SEGMENTS 9a, 9b and 12 WATER SYSTEM IMPROVEMENTS CASCADE METROPOLITAN DISTRICT NO. 1

EROSION CONTROL PLAN - SEGMENT 8a & NOTES
WATER SYSTEM IMPROVEMENTS
CASCADE METROPOLITAN DISTRICT NO. 1

EROSION CONTROL PLAN - SEGMENT 7b
WATER SYSTEM IMPROVEMENTS
CASCADE METROPOLITAN DISTRICT NO. 1

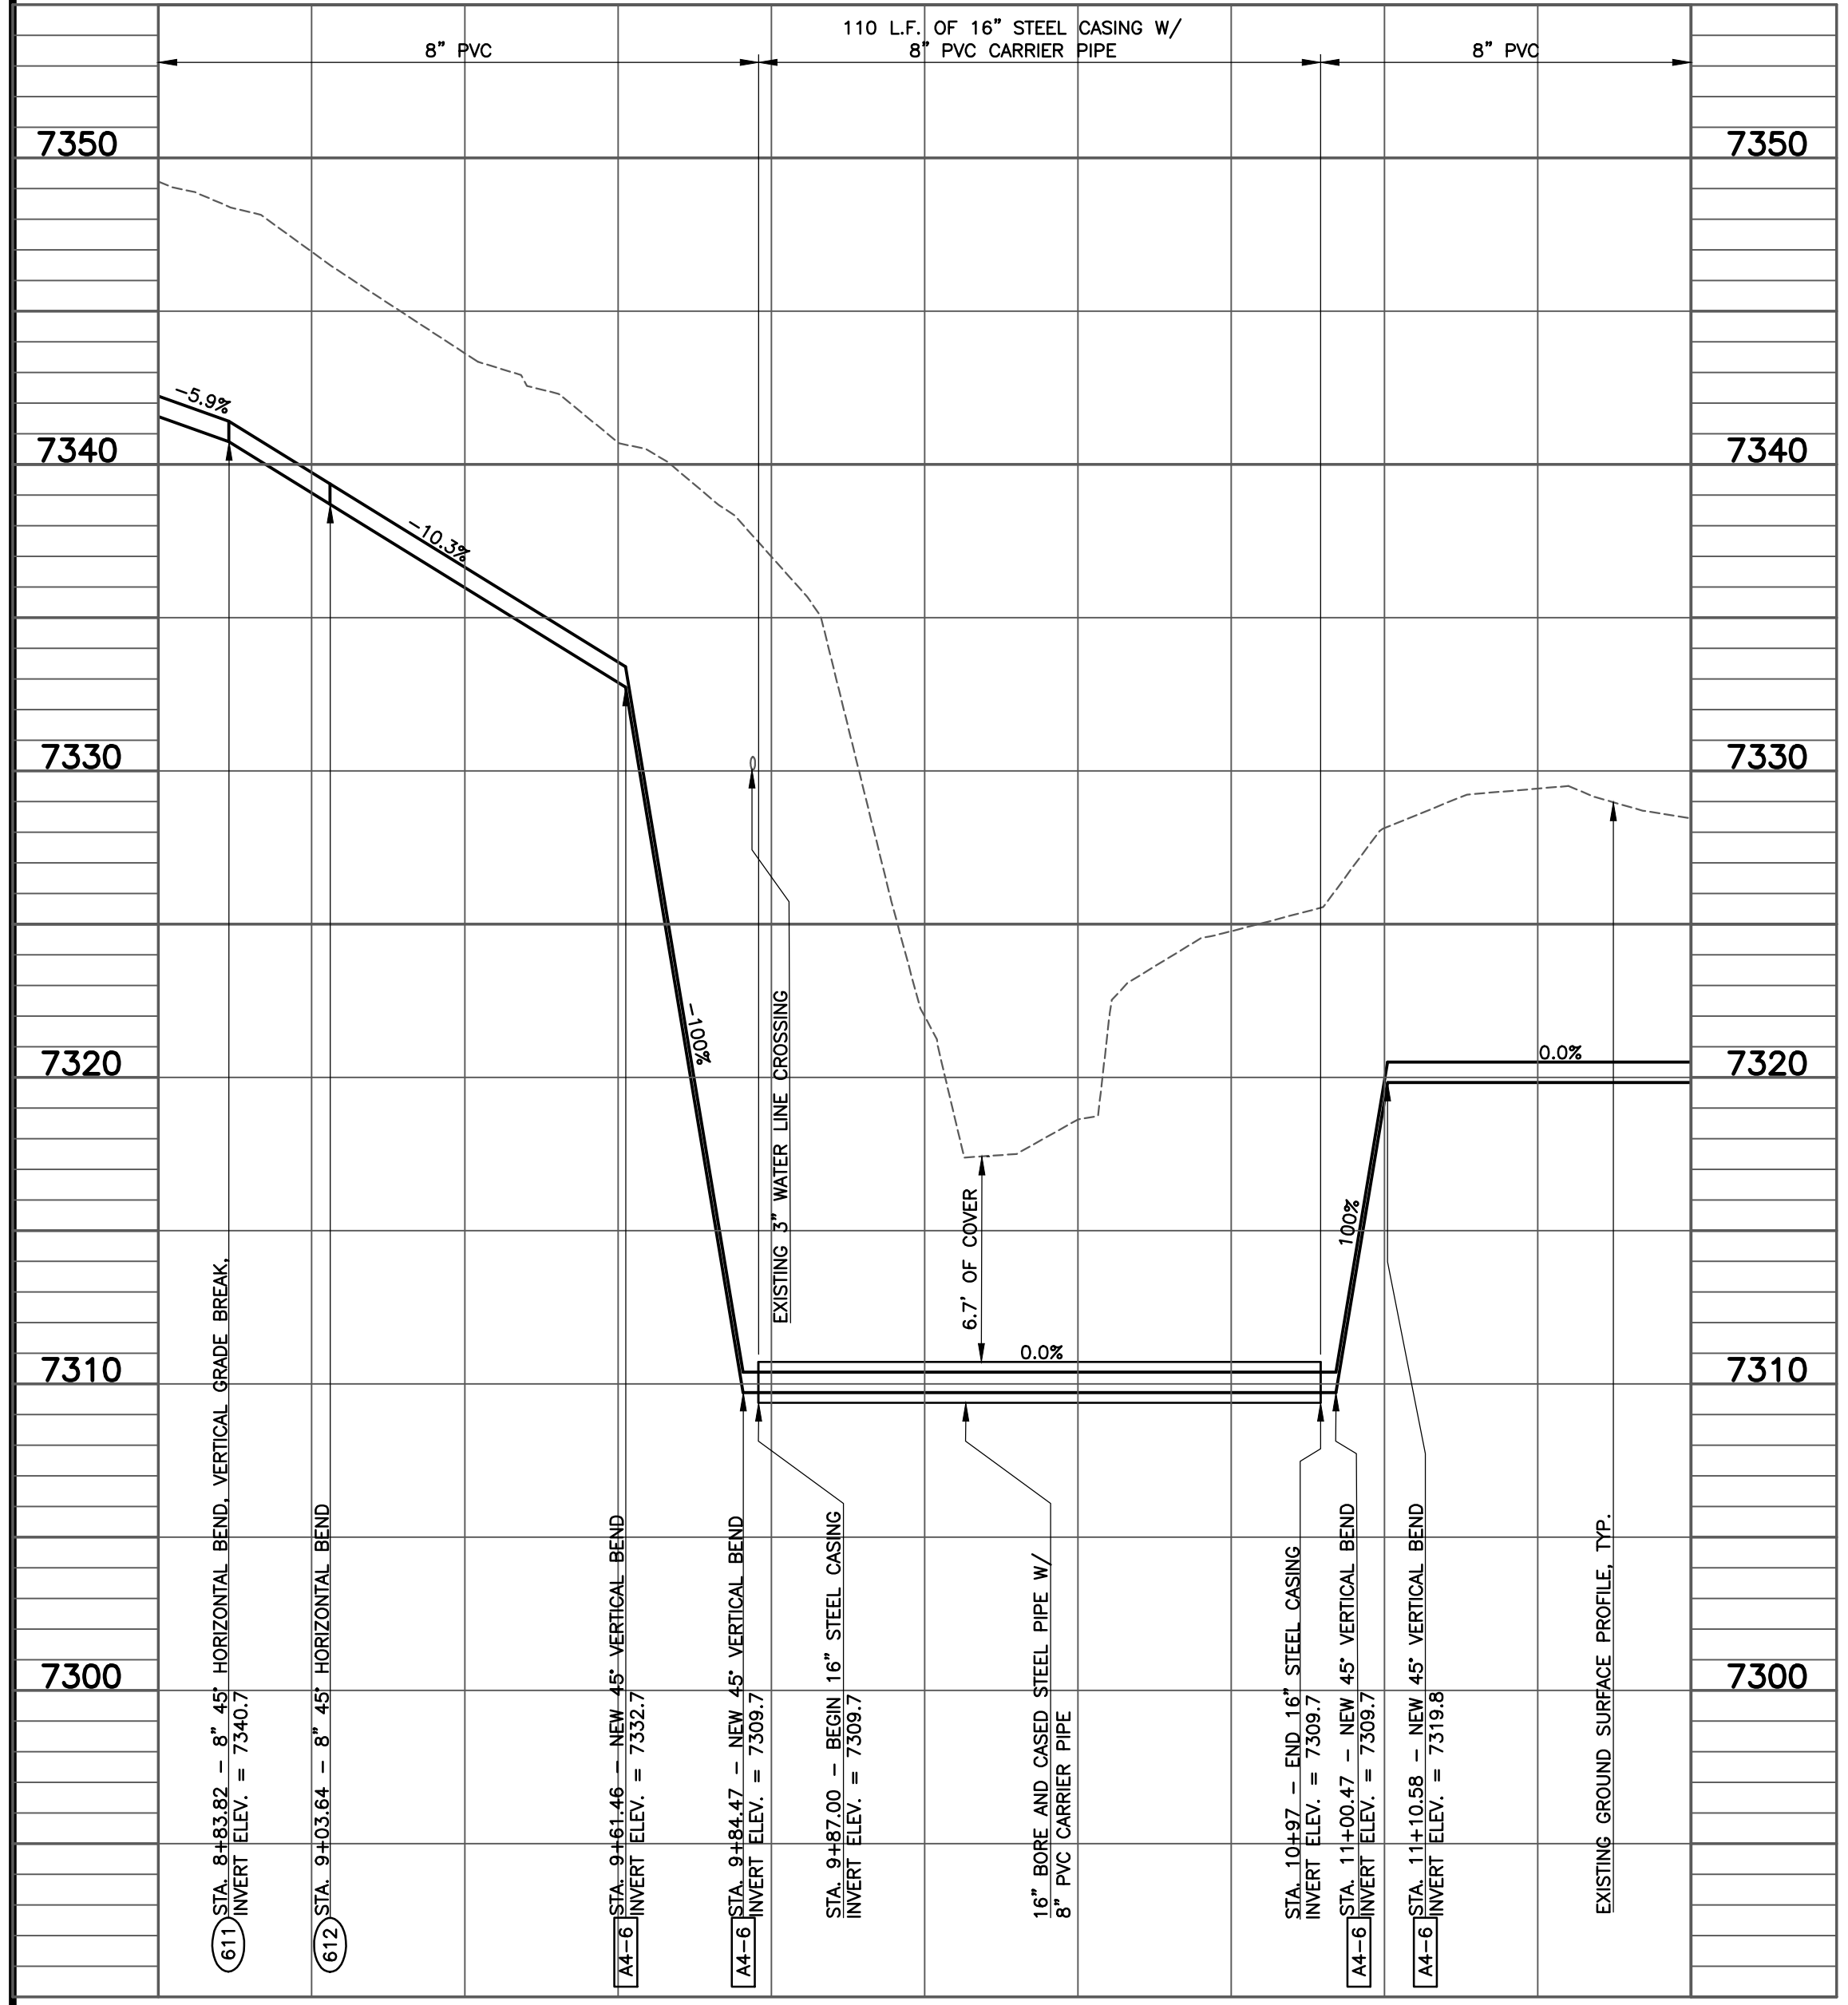
Show excavation(s) for crossing and trench detail if open cut.

Is this bore or open cut?
SEE PROFILE BELOW.

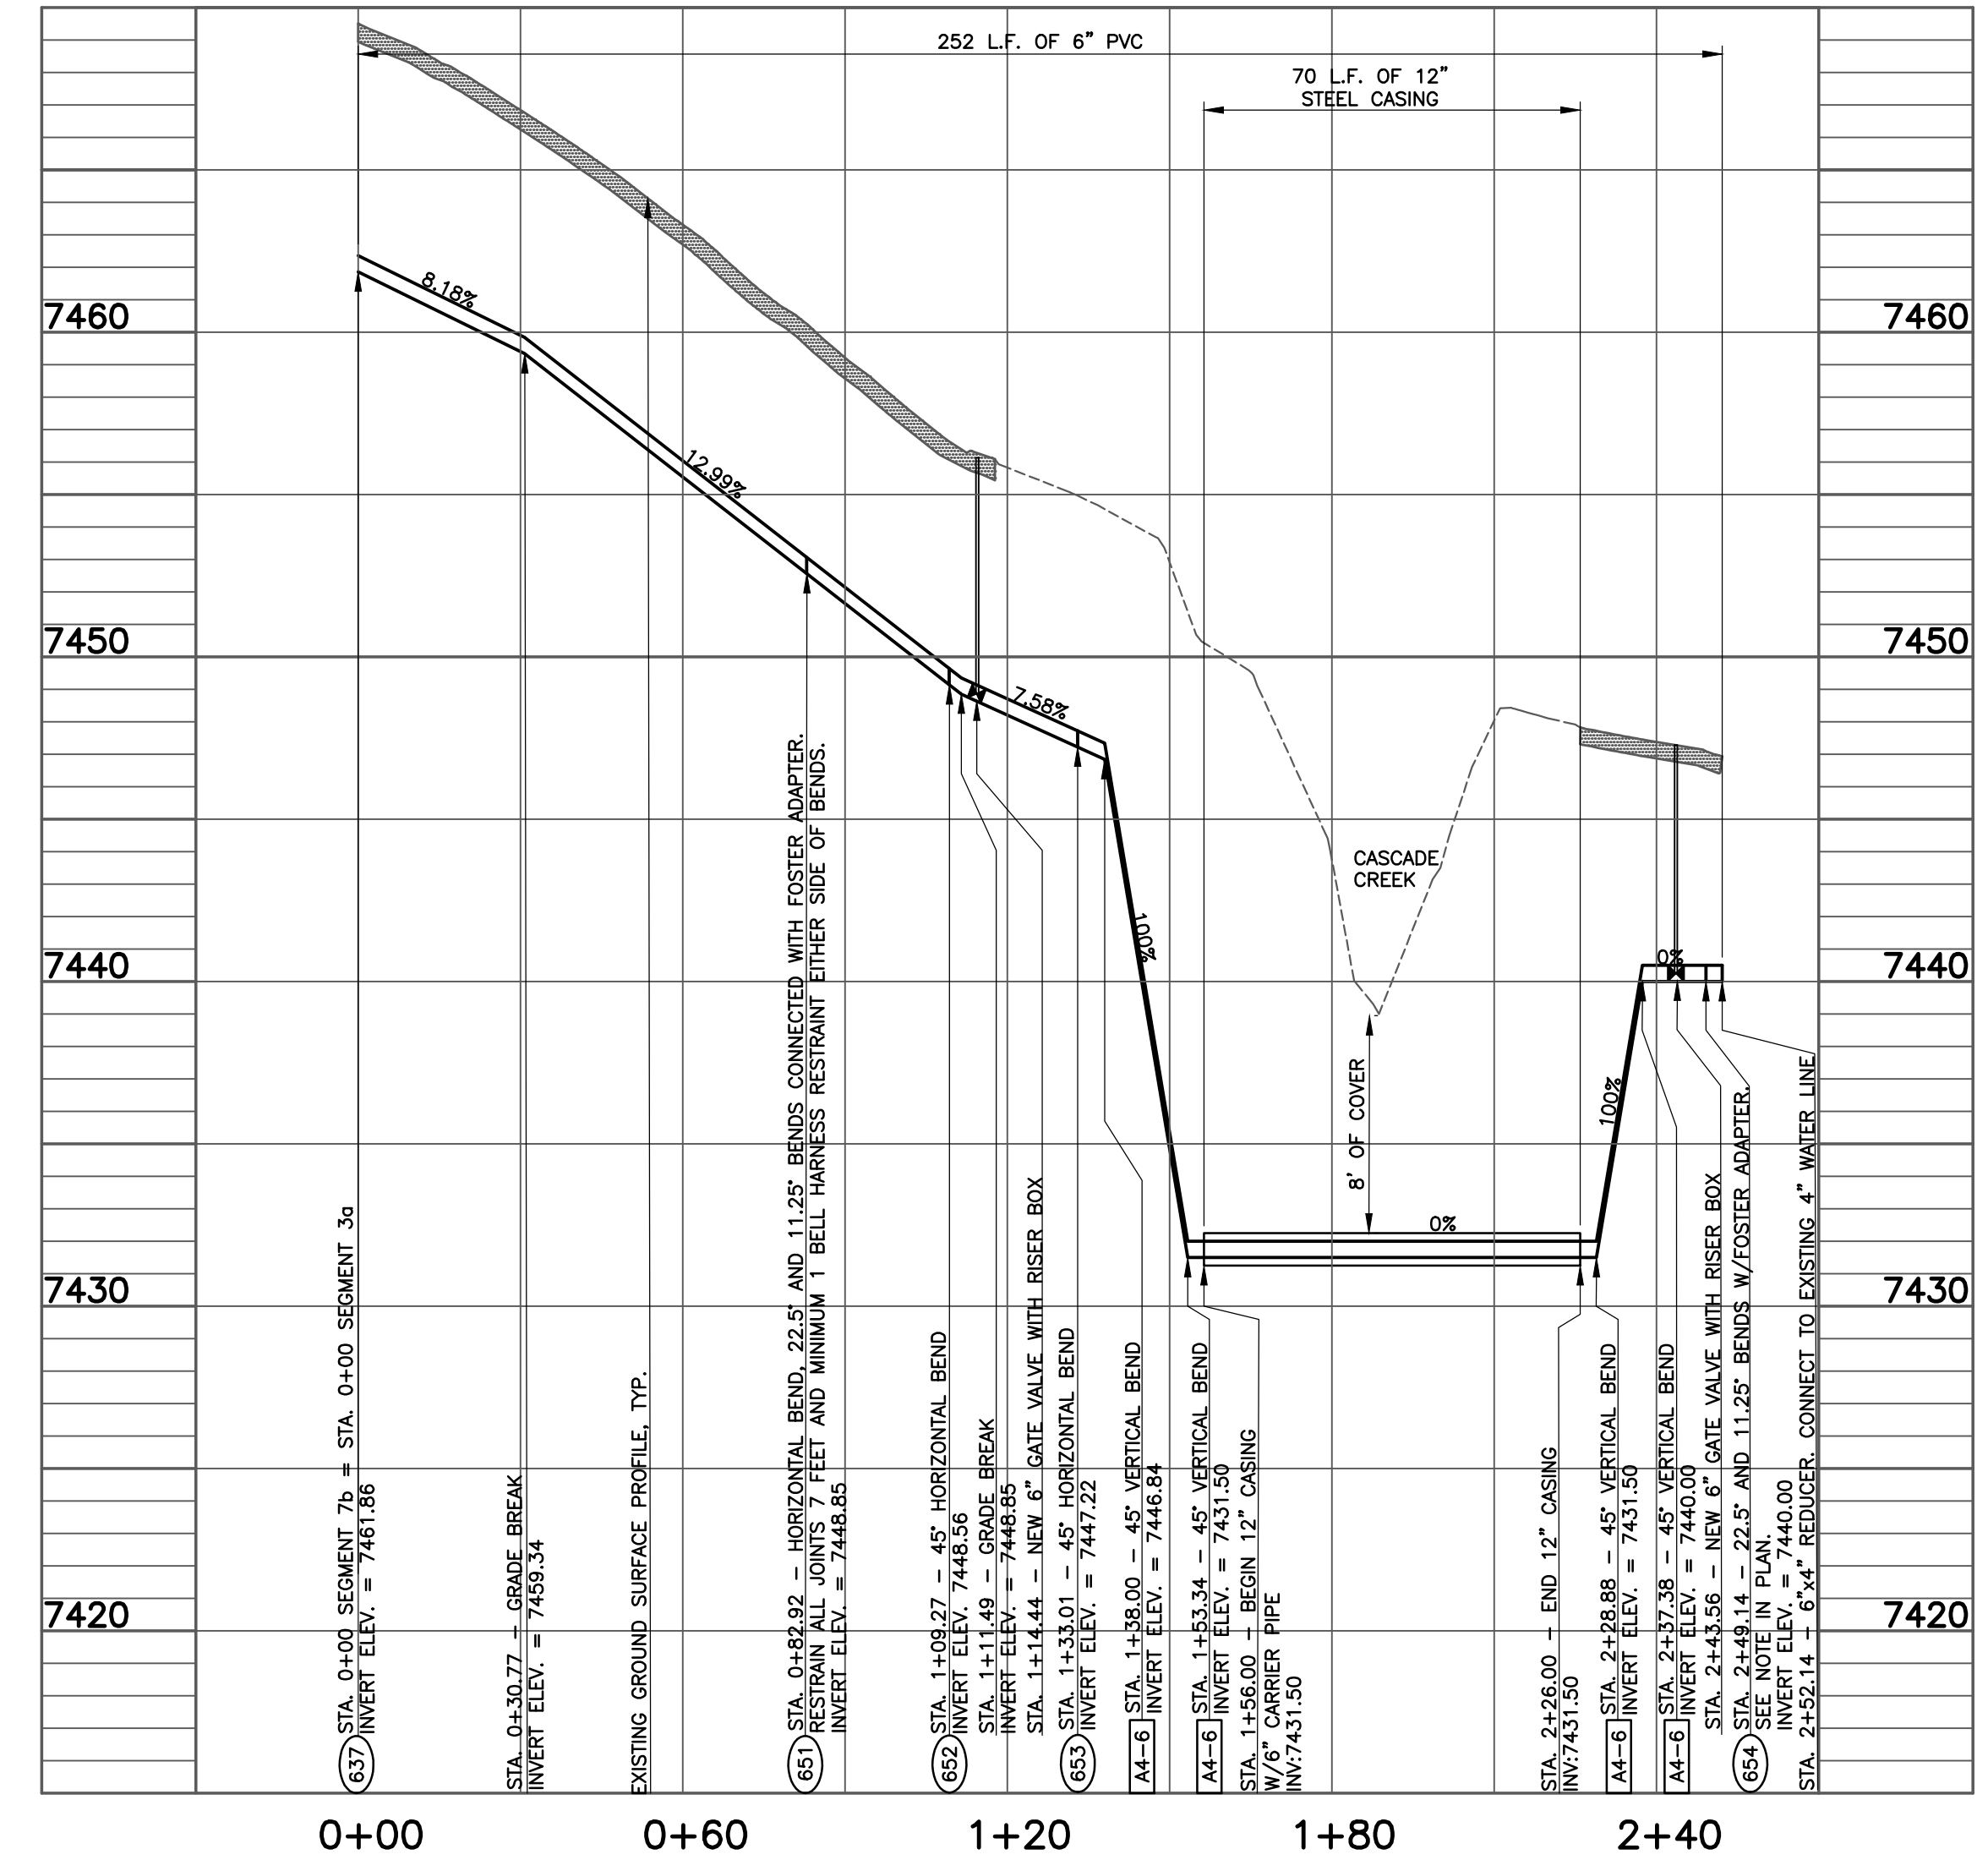
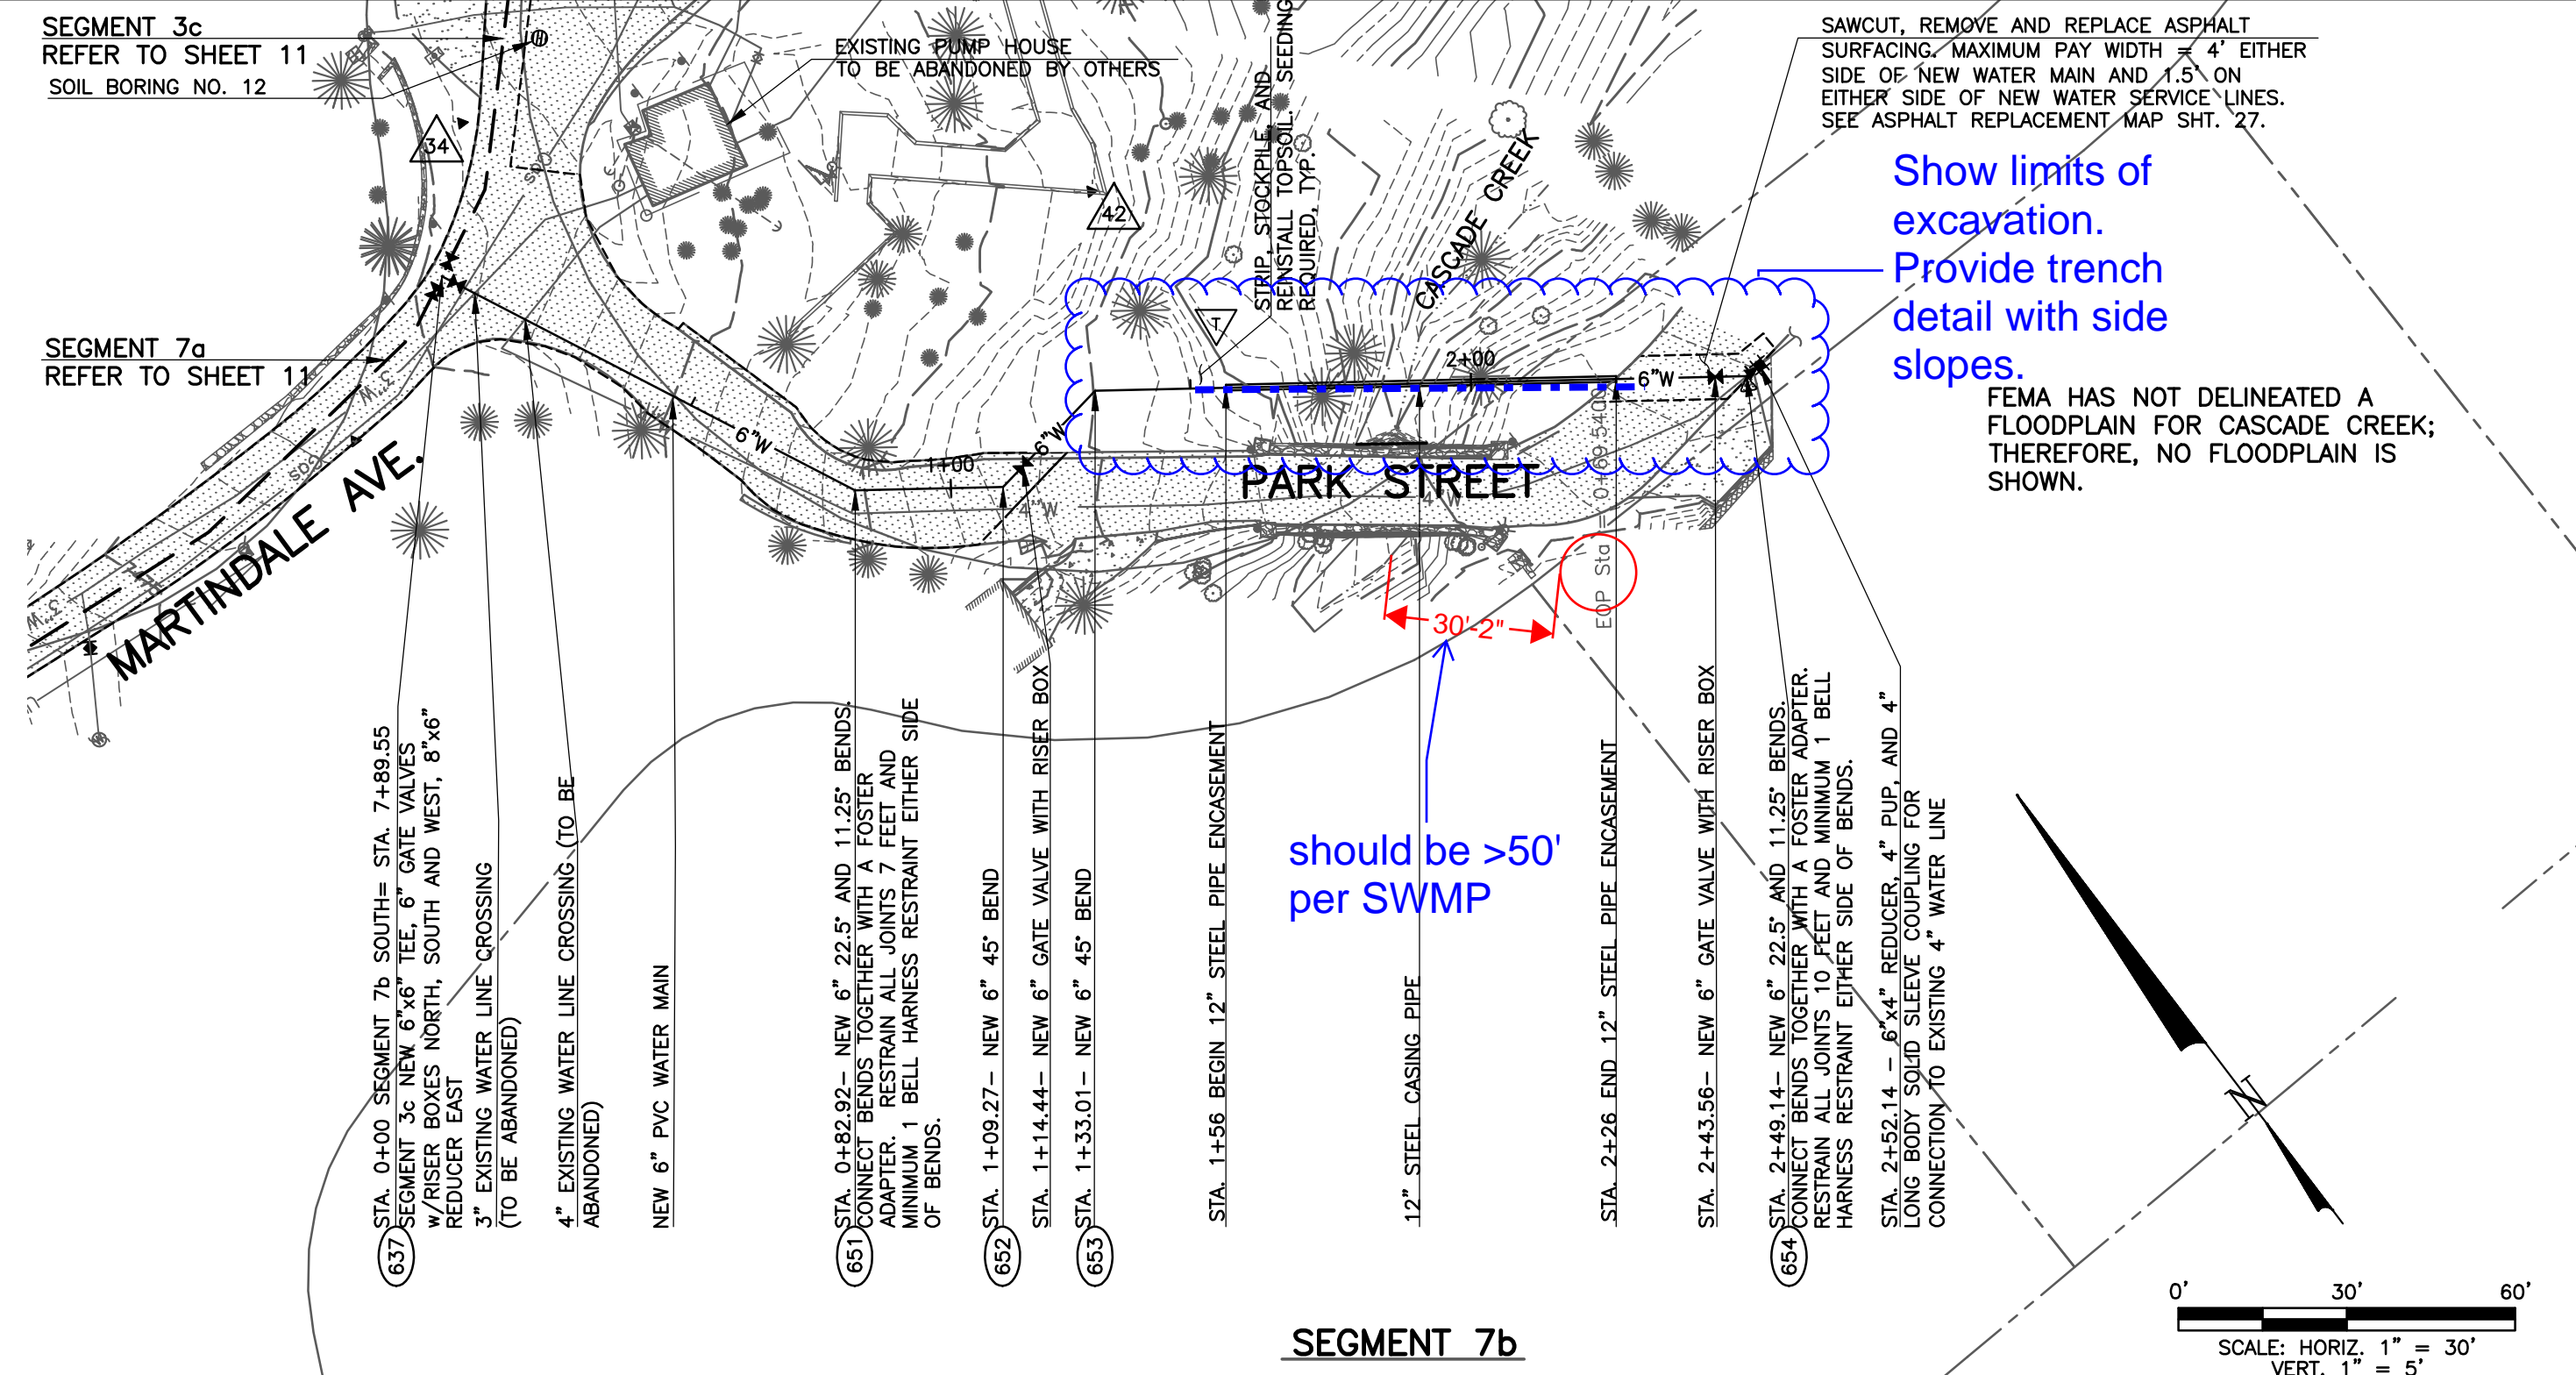
Provide sheet 21 in SWMP
